Town of Cottesloe
Attention: Ed Drewett
109 Broome Street
Cottesloe WA 6011

Lot 92, 257 Marmion Street Cottesloe – Application for Approval to Commence Development

In response to your letter dated 22nd May 2013, please find amended plans attached and our responses below to the relevant issues raised.

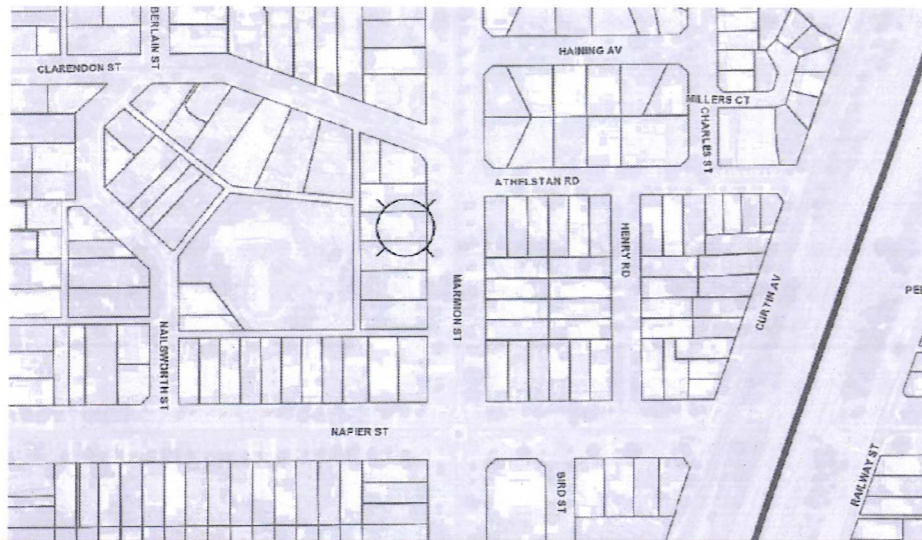
- 8. Any proposed fencing in the 6m front setback area can be solid to a maximum height of 0.9m and must be 'open-aspect' above to a maximum height of 1.8m. The proposed fencing does not satisfy this requirement.**

We have changed the proposed fencing design to comply with this requirement as shown on the amended drawings enclosed. Those portions above 900mm to a maximum of 1800mm feature 50% open aspect.

TITLE
FIRST FLOOR PLAN

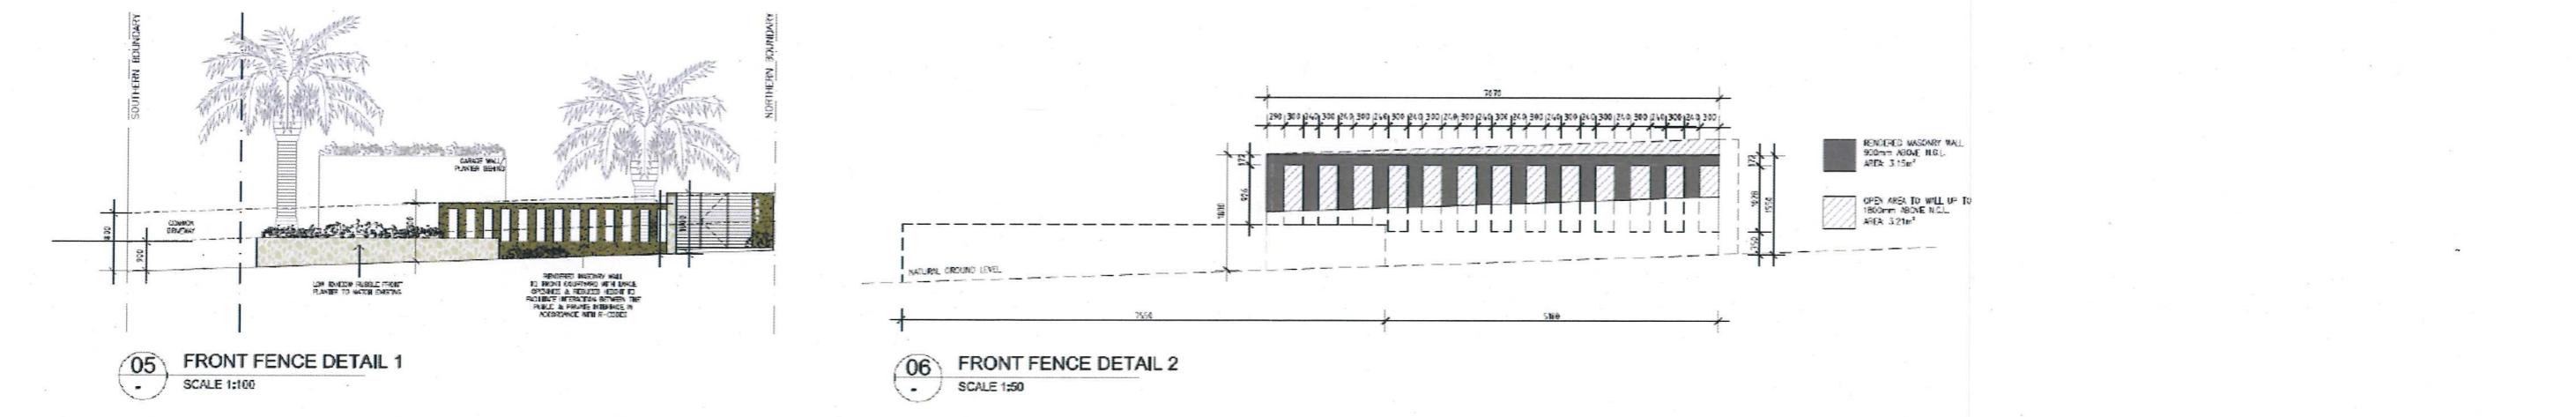
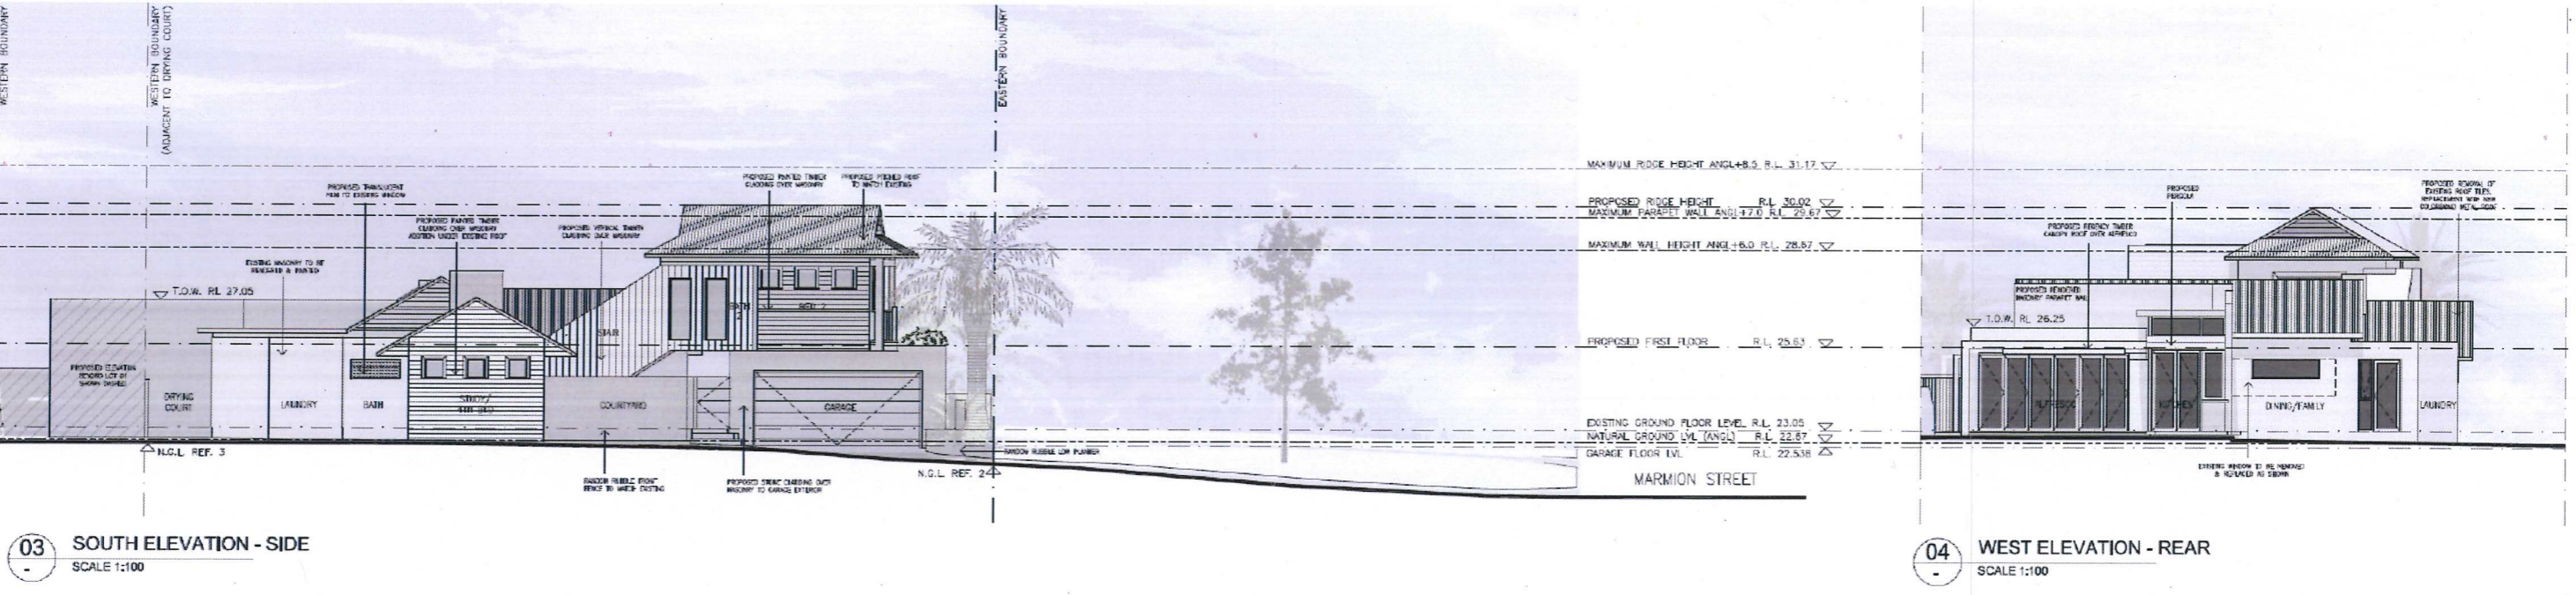
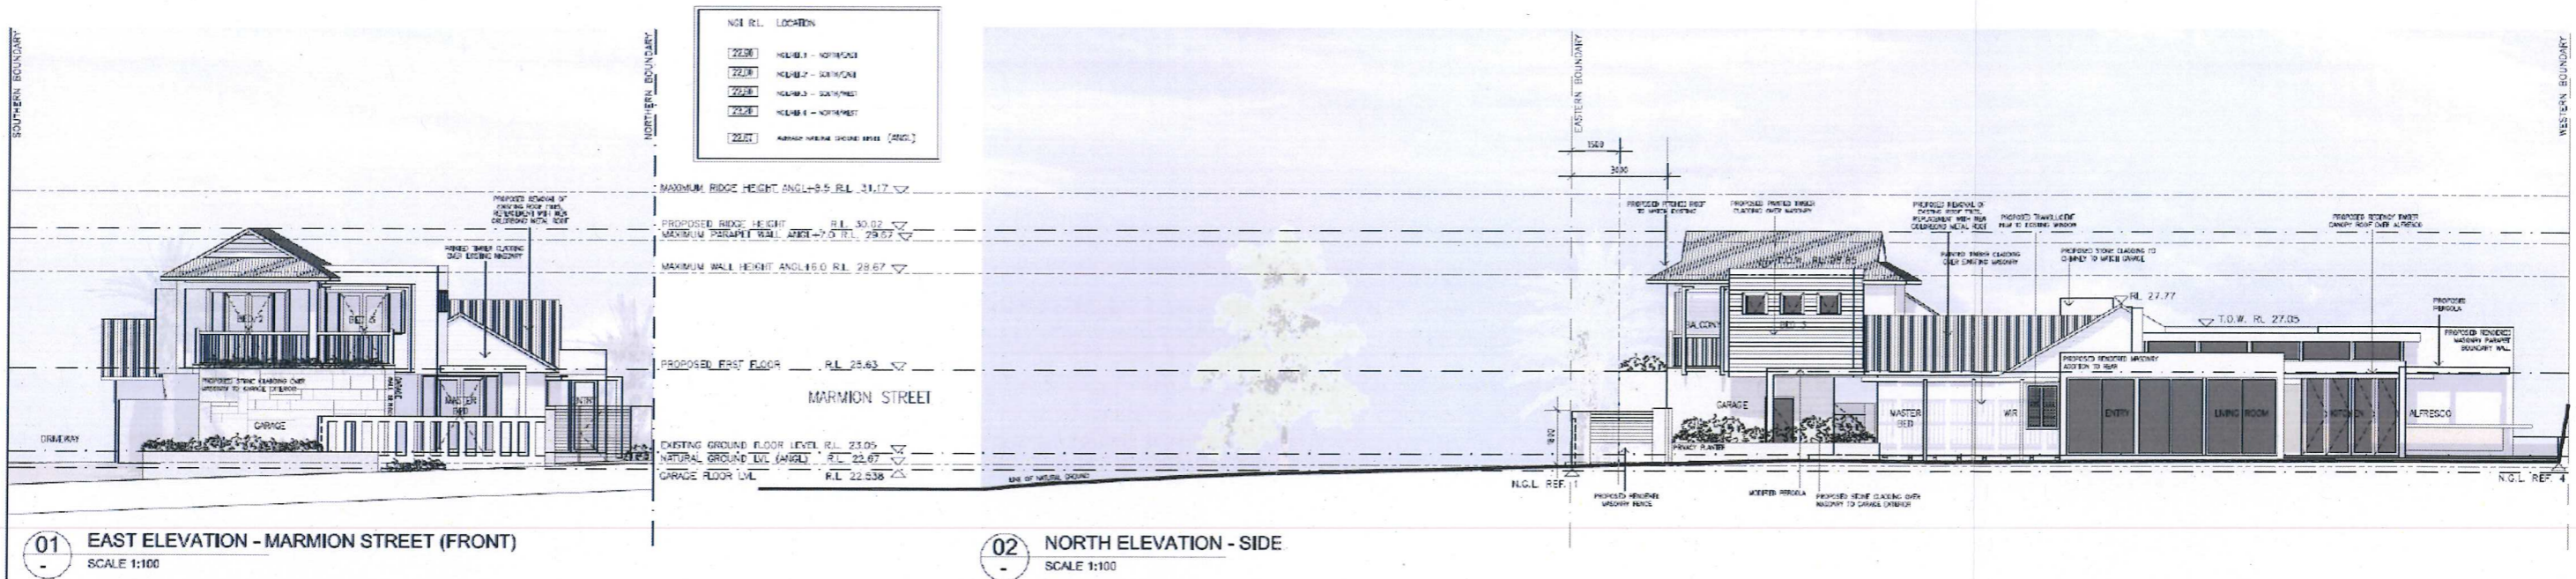
7. ***A minimum 7.5m cone of vision is required from the proposed front balcony to the southern boundary. This may be addressed under performance criteria in view of the location of the existing garage on the southern property;***

Your comment is correct in as much there is a cone of vision to the first floor balcony that needs to be addressed. We have amended the drawings to show the relationship of this viewing line as it relates to our neighbour. We did not believe it would be an issue based on the performance criteria of the R codes as:-

The cone of vision of the proposed balcony had been illustrated on the drawing set (DA03) which revealed the cone does intrude onto the neighbouring property. The implementation of permanent, mature vegetation (at the expense to the owner of the proposed residence) had also been illustrated on the above-mentioned drawings. It is to be noted that the location of the proposed balcony has not been situated for the sake of views. It has been intended that mature vegetation (which will be 3.5m - 4.0m in height upon installation) selectively planted in a location and be allowed to grow naturally higher, as a means of further screening and enhancing privacy. The cost of the mature tree will be in the order of \$3,000 - 5,000 and will not be allowed to deteriorate due to the expense of installation and the desire to create an intimate inward-looking first floor outdoor space rather than outward-looking. This acts as a natural screening device which is as much an aesthetic response dealing with the issue of overlooking to the affected property. We believe this satisfies the performance criteria for this design element and allows for the privacy of the neighbouring property to be enhanced.

257 MARMION STREET COTTESLOE

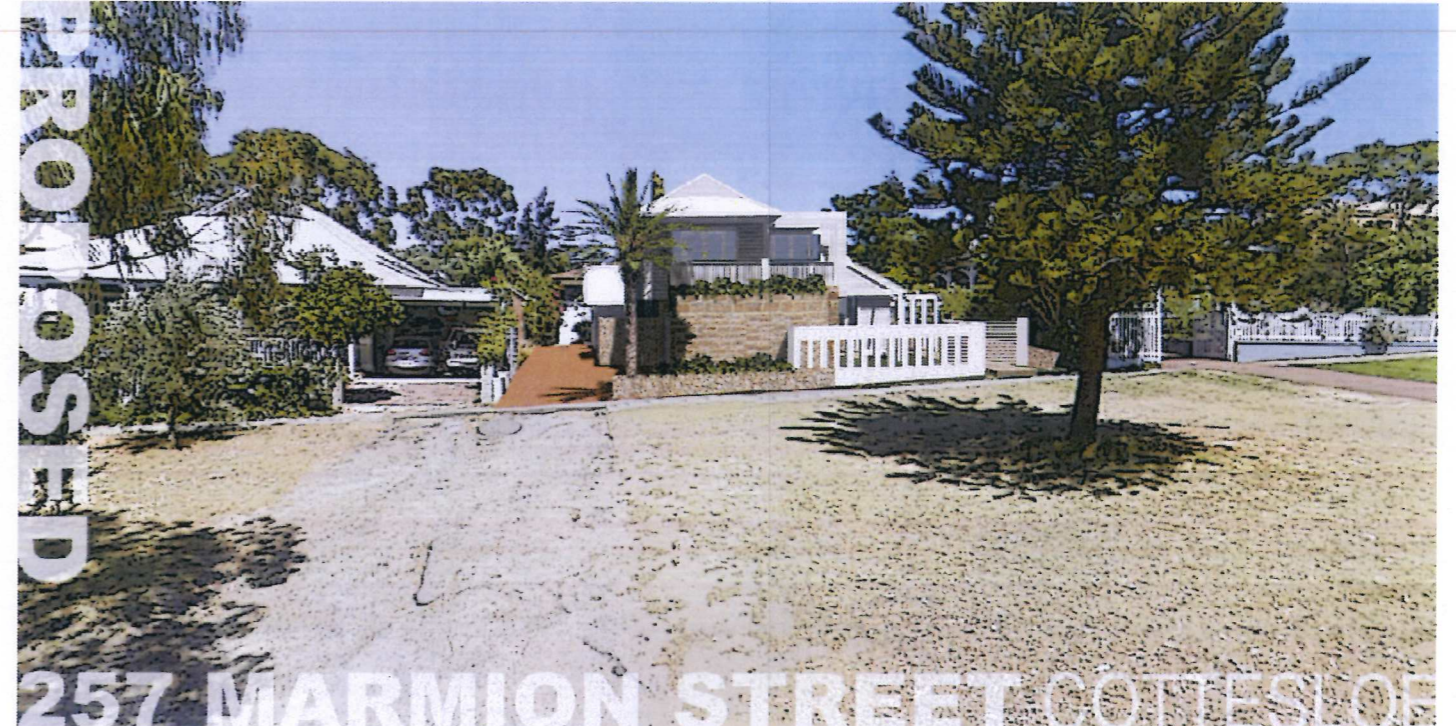
2. ***Council may consider a reduced front setback to the proposed garage at 1.5m only if the criteria in the Council's Policy for Garages and Carports in Front Setback Area has been satisfactorily addressed. This requires the garage to be in character with the residence on the site and in harmony with the surrounding streetscape. It also requires, amongst other things, consideration of the effect of such a variation on the amenity of any adjoining lot and existing setbacks from the street alignment in the immediate locality, in the case of setback from the principal street alignment. As both adjoining properties are listed on the Town's Heritage Municipal Inventory and have generous front setbacks (including the existing dwelling on the site) it is considered that the proposed reduced front setback would not satisfy the Policy requirement as the garage location would be out of keeping with the existing streetscape, detract from the amenity of the adjoining dwellings, and be contrary to orderly and proper planning in the locality;***

We believe the outcome provides a design, as shown on the enclosed streetscape drawing DA05) as it relates to the architectural presentation to the street, that is:

The front additions to the existing residence have been centrally positioned on the site so as to not restrict the viewing lines of either neighbour when viewed from the streetscape. The preservation of these sight lines toward both heritage listed properties was of paramount importance during the design process.

Locating the vehicular entry to the garage parallel to Marmion Street enables the existing single driveway & cross-over (which also serves both the southern and western neighbour) to be utilised. This negates the need for a potentially dominating additional cross-over resulting in a largely unaffected street verge.

The proposed front fence seeks to solve the disconnect of front boundary elements within the immediate context. The design forms a connection with and responds to the street presentation of both neighbours and their respective streetscape treatments. As illustrated in the proposed sightline view, the proposed open aspect white fence forms an extension with similar scale to the existing "white" picket fence to the north. The integrating low "random rubble stone" planter creates a visual link with the softer, more natural elements of the southern neighbour, overall resulting in a comfortable and balanced streetscape.
